METRO FLOOD DIVERSION AUTHORITY

Thursday, November 10, 2016

**METRO FLOOD DIVERSION AUTHORITY
OCTOBER 27, 2016—3:30 PM**

Removable floodwall closure (length 64'-0")

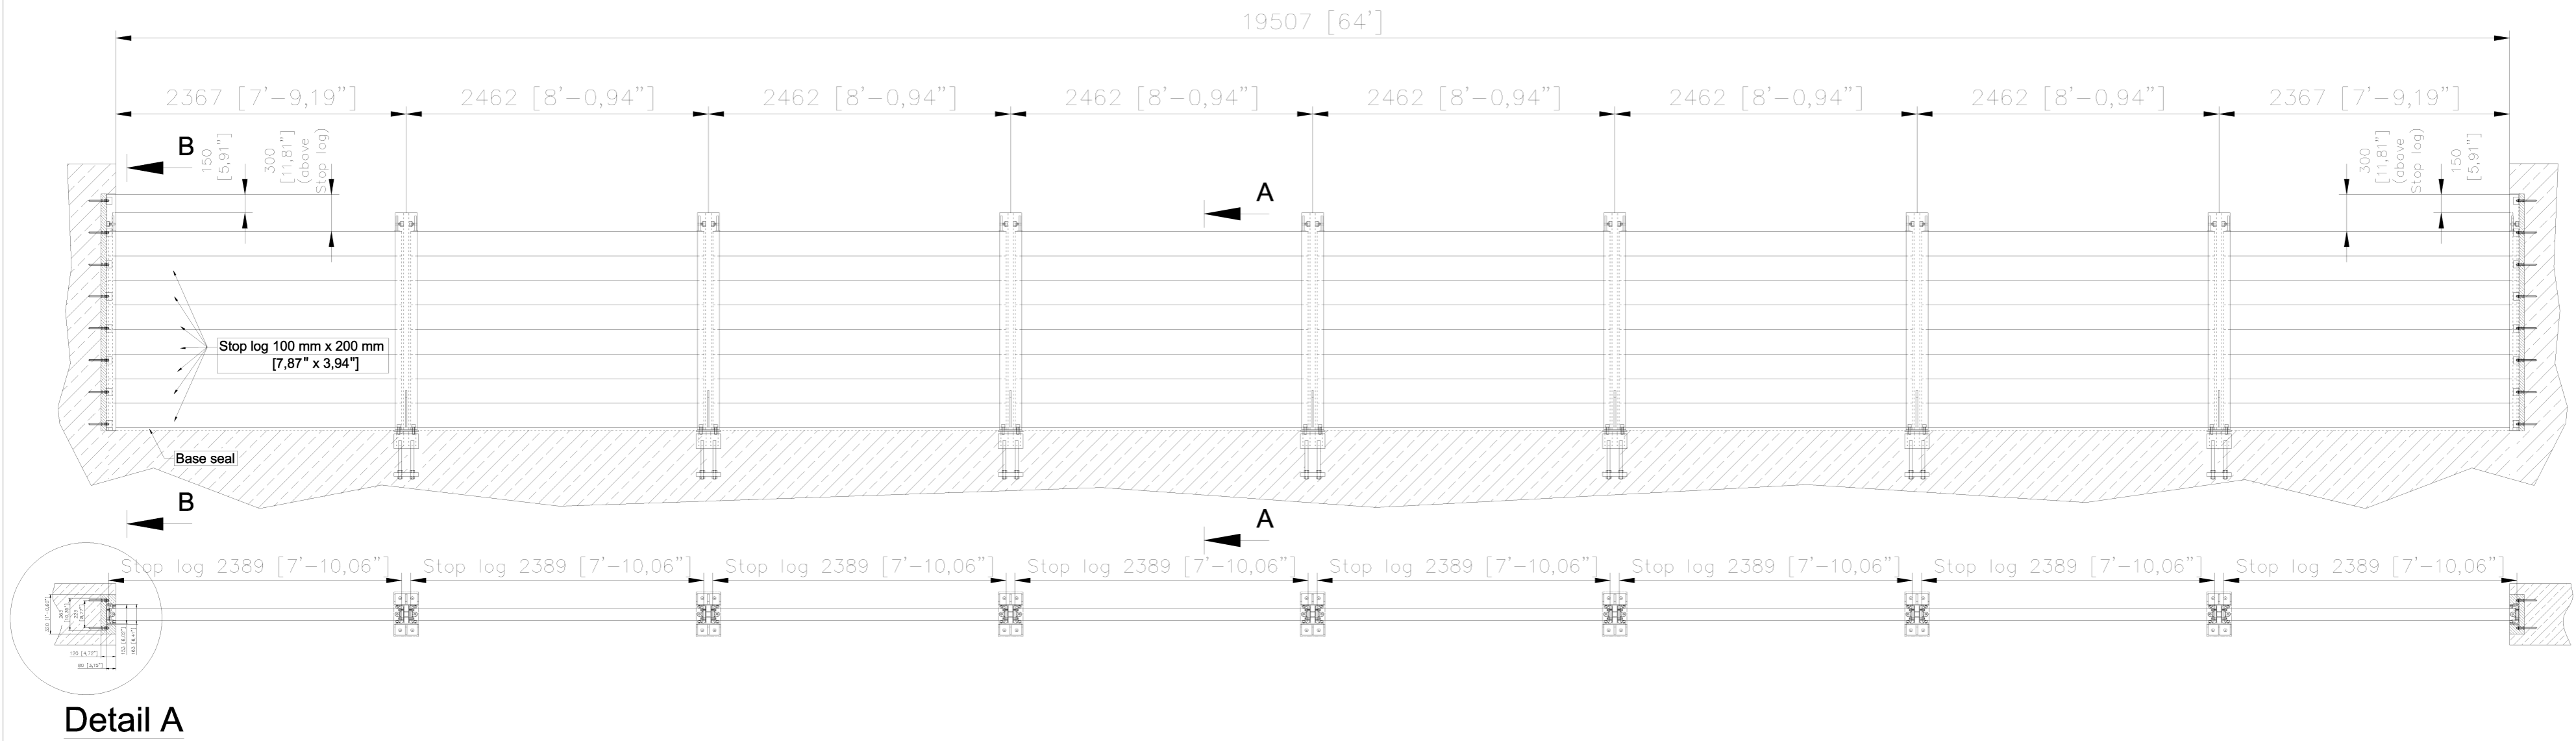
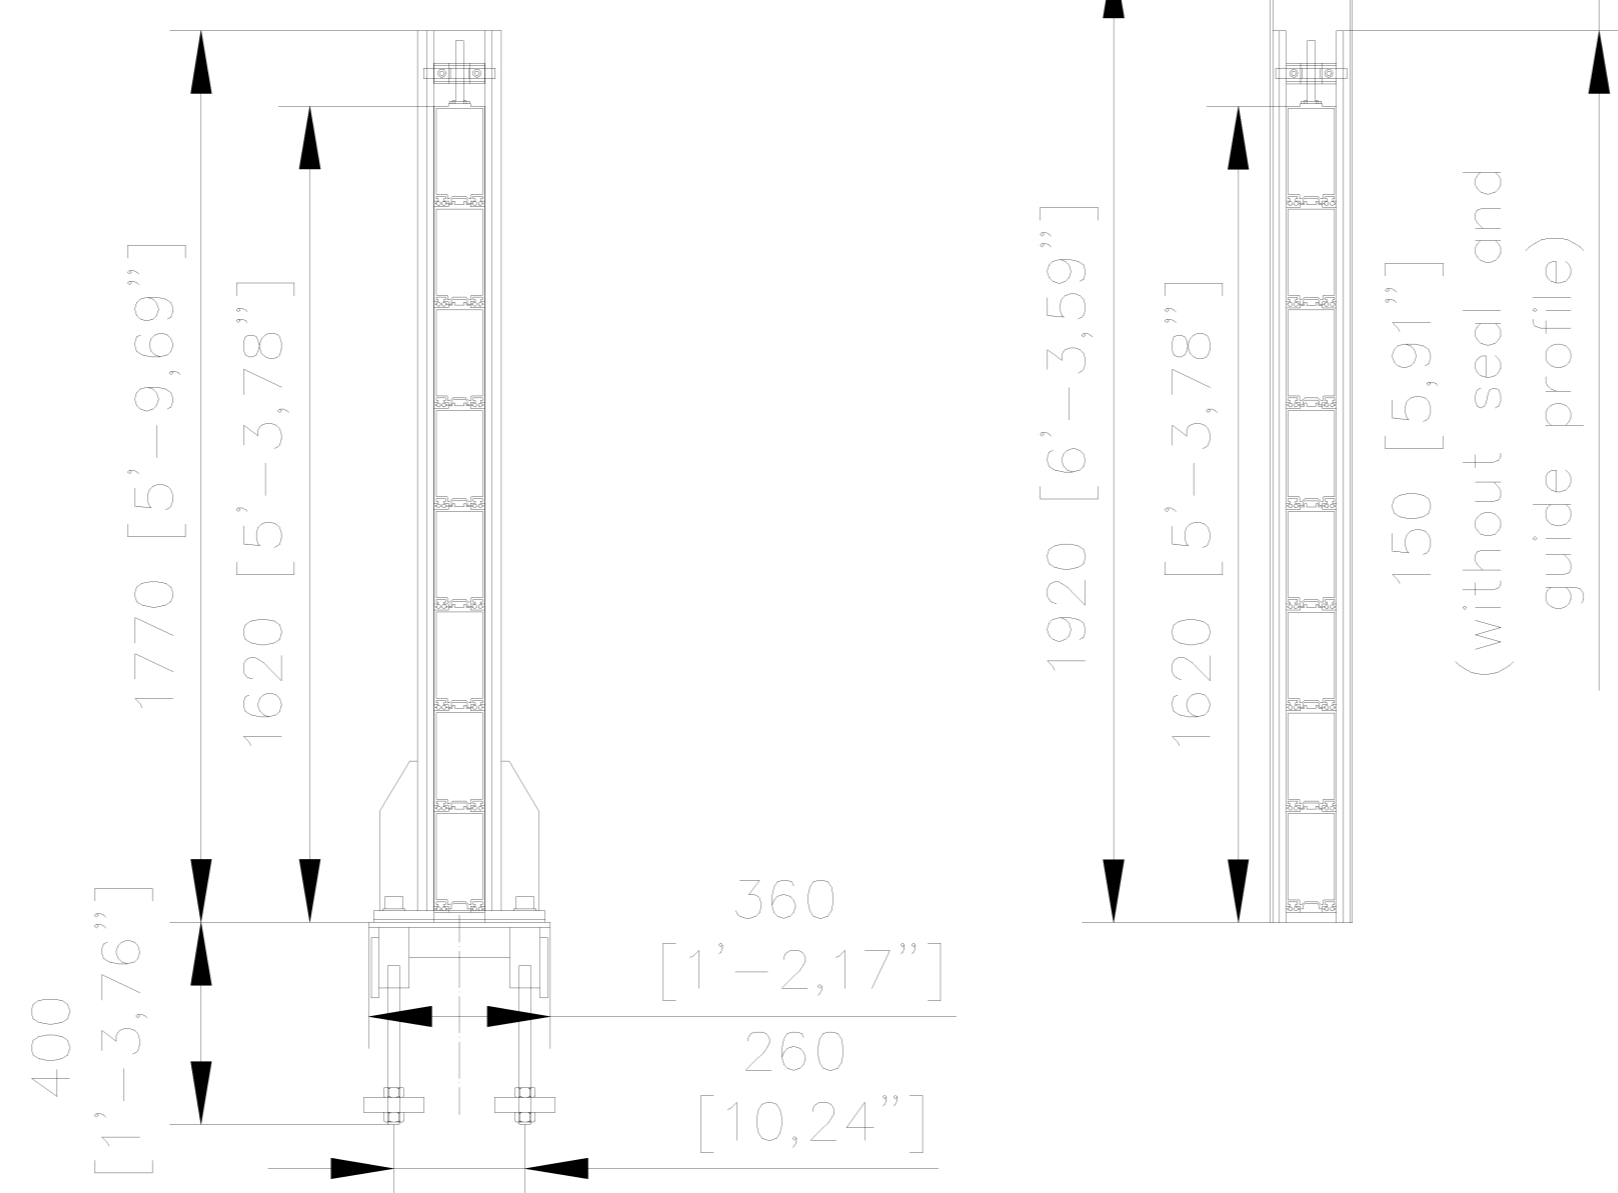
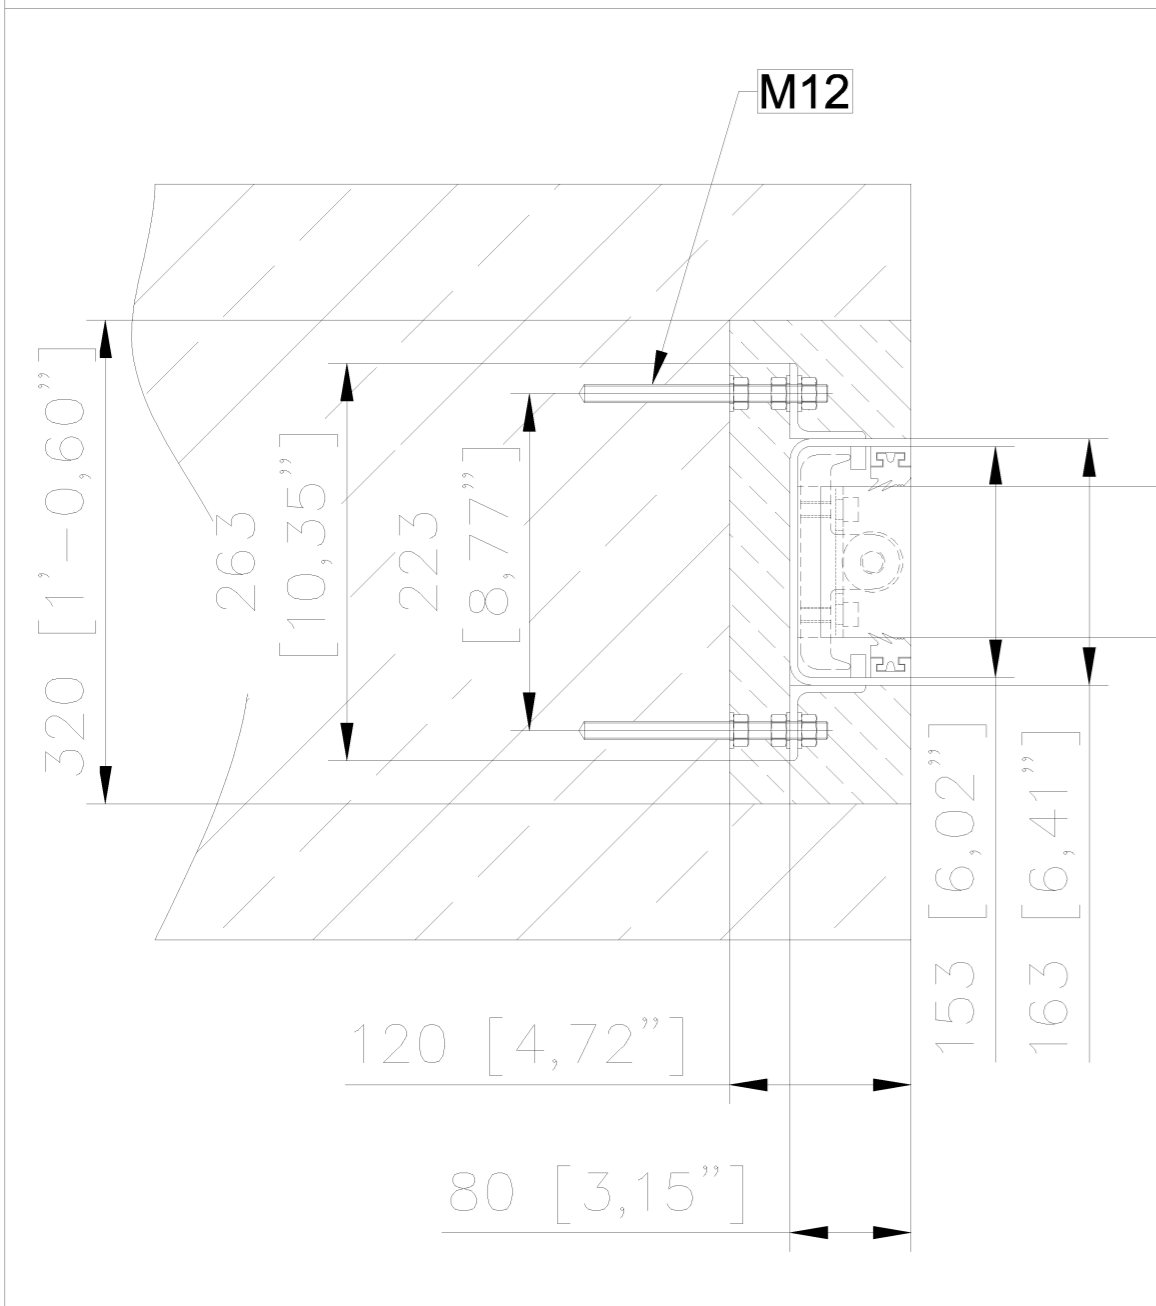
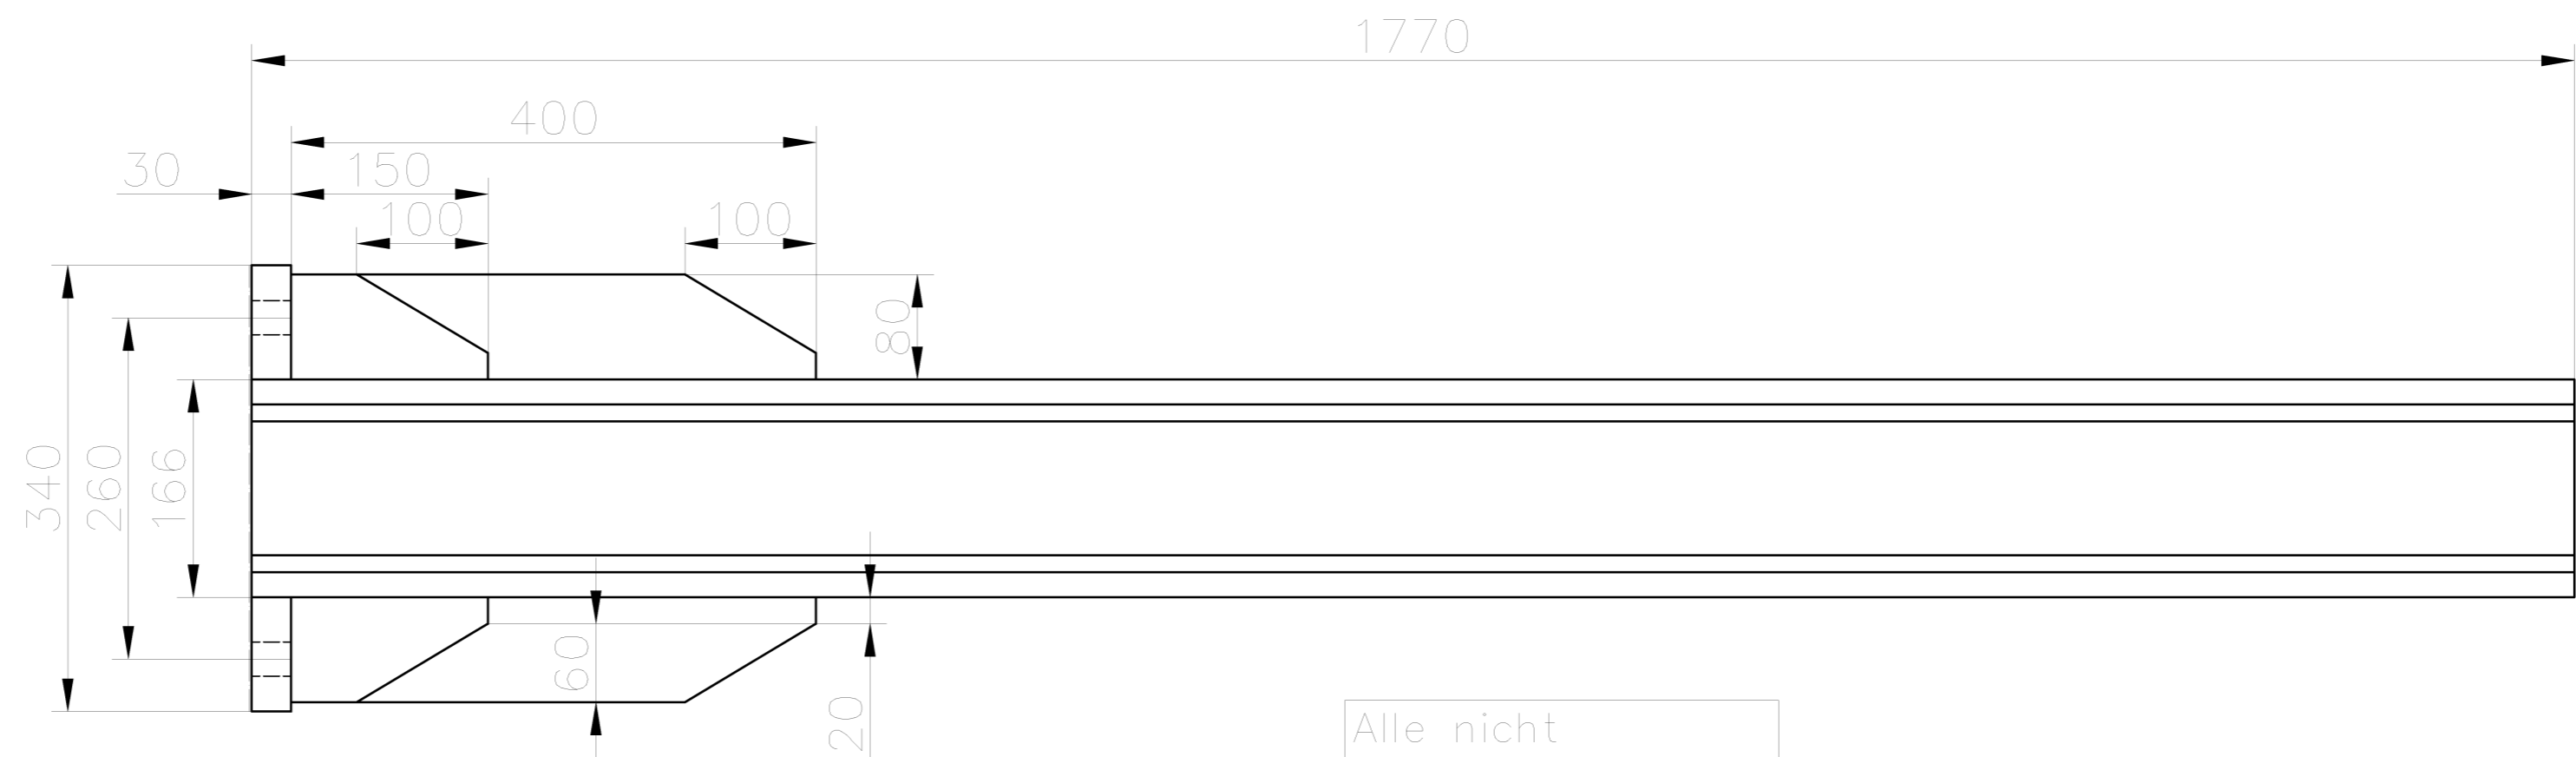
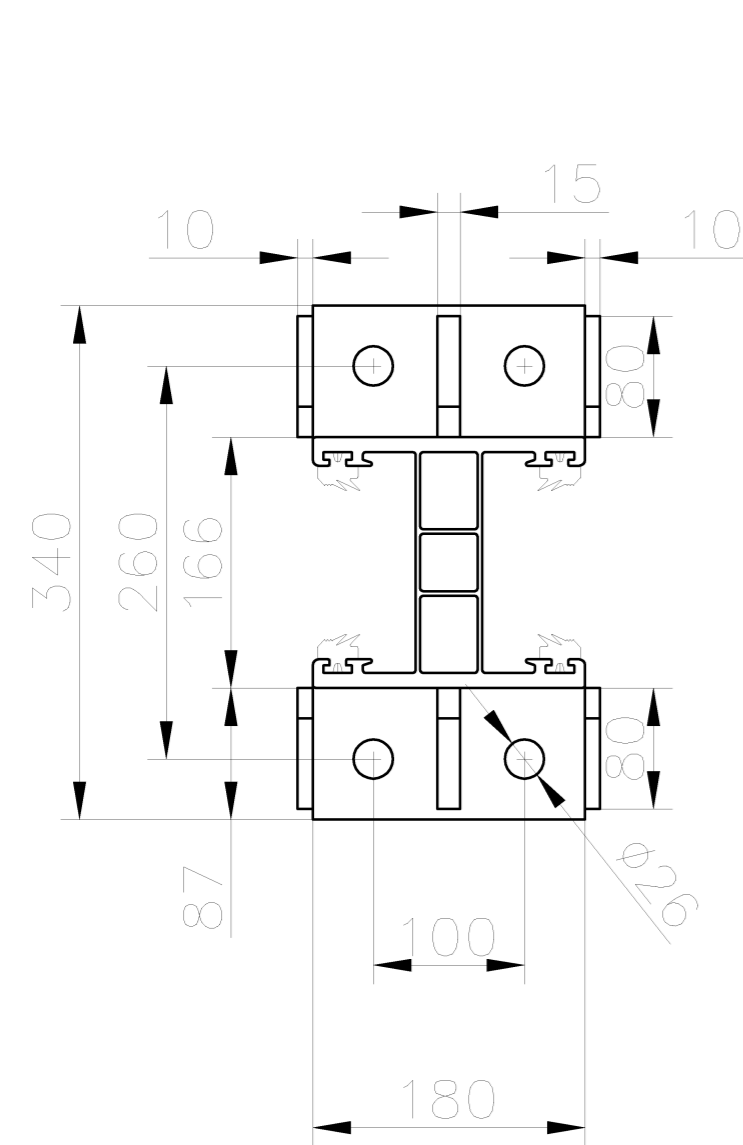
1. Sheet C-060-3, dated 12-30-2016, showed proposed elevations of 899.00 labeled "temp wall base." Sheet C-060-3 also referenced Sheet C-070-3. Sheet C-070-3, dated 12-30-2015, showed correct top of concrete elevations of 899.00 along the temporary floodwall. When the temporary floodwall embeds were placed, but prior to pouring of concrete, the contractor had the opportunity to shoot the elevations of the embeds to verify that they were at elevation 899.00.

3. Structural detail 2/S502 has text on the detail as 8" Concrete Slab for Approach, See Civil. This detail has the vertical dimension of 5'-0" that was intended to represent minimum cover, not top of foundation wall. The note to see Civil was a flag to the Contractor to verify the actual dimension. All the other drawings and details in the contract documents related to the floodwall were correct.

catalog numbers, and similar information with respect thereto;" If contractor was following structural detail 2/S502 and believed the base of the floodwall would be at elevation 898.33 instead of 899.00, then they should have ordered a taller temporary floodwall to reach the required top of wall elevation of 903.4.

3. Structural detail 2/S502 has text stating 8" Concrete Slab for Approach, See Civil. This text does not have, nor does it reference an elevation or to verify elevation with civil. All of the information needed to build the floodwall is provided on the structural drawings. This text indicates that concrete pavement is a subsequent activity and information in that regard are to be found on the Civil plans. Additionally, you state that the vertical dimension of 5'0" was intended to represent minimum cover, not top of foundation wall. We cannot assume anything of the intentions of a dimension provided on the structural plan. The dimension shown is 5'0" and that was how the wall was built.

This claim is submitted after careful consideration of your response letter dated August 22, 2016. The elevation error on the structural plans, specifically Detail 2/S502, made it through all the review processes with no revision or clarification. Accordingly, we believe that an equitable adjustment to the contract is warranted for the replacement floodwall material and traffic control to mitigate the problem per our Request for Change Proposal dated August 15, 2016. In addition to the amount of \$27,200.77 from our request for change proposal, we request the cost to air freight the end channels in the amount of \$1,161.50. This will enable timely installation of the end channels and provide the necessary cure time prior to the deployment demonstration.

Response	A Non-Conformance Notification was issued. Reiner will check with their supplier to determine if new posts can be ordered and the temporary floodwall raised an additional eight inches. If the floodwall can be raised eight inches, Reiner will verify with supplier that the floodwall components can safely withstand the additional stresses caused by an additional eight inches of floodwater pressed against it. If floodwall can be raised eight inches, then revised grading plans will be created to accommodate the floodwall base being eight inches lower than originally planned.

If floodwall can be raised eight inches, then revised grading plans will be created to accommodate the floodwall base being eight inches lower than originally planned.
